Subject: ATTENTION: Revised edition of my submission sent previously today on Monday 10th February. Please use this as my current updated submission.

Additional comments RE- Proposed Seniors Development 27&29 North Avalon Road, North Avalon.

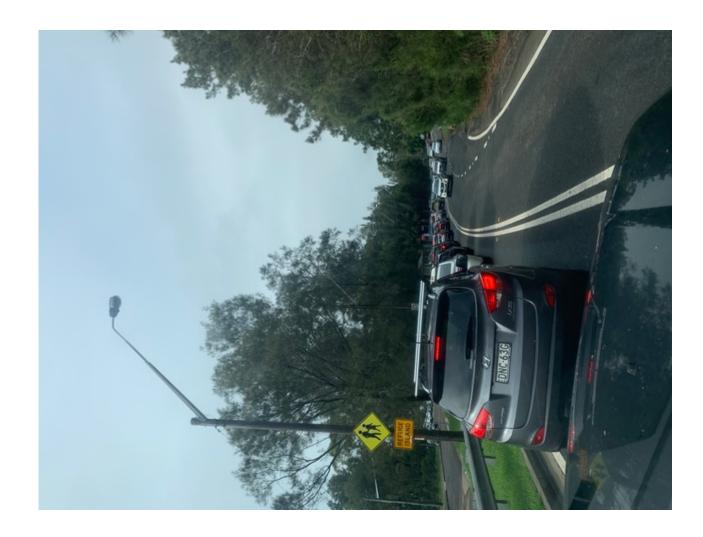
Please note to the left of this photo, the traffic banked up in North Avalon Road and Catalina Cres, trying to get out onto Barrenjoey Road.

Then they too will join the other massive traffic jam on Barrenjoey Road. We should not have to leave North Avalon an extra half an hour earlier every morning than we need to, just to get into Avalon on time????

We can clearly see from this photo and video, this is absolutely not the case and traffic will be greatly increased and impacted from this development.

We therefore ask that the Council to request further assessment be undertaken to provide more detailed analysis and data. There needs to be a Traffic Modelling Statement undertaken and prepared with the traffic assessment

period being extended from 7-9.30am and 3-6pm, to reflect the before and after school traffic, as Avalon Primary does not start until 9.30, and finishes until at 3.30pm.
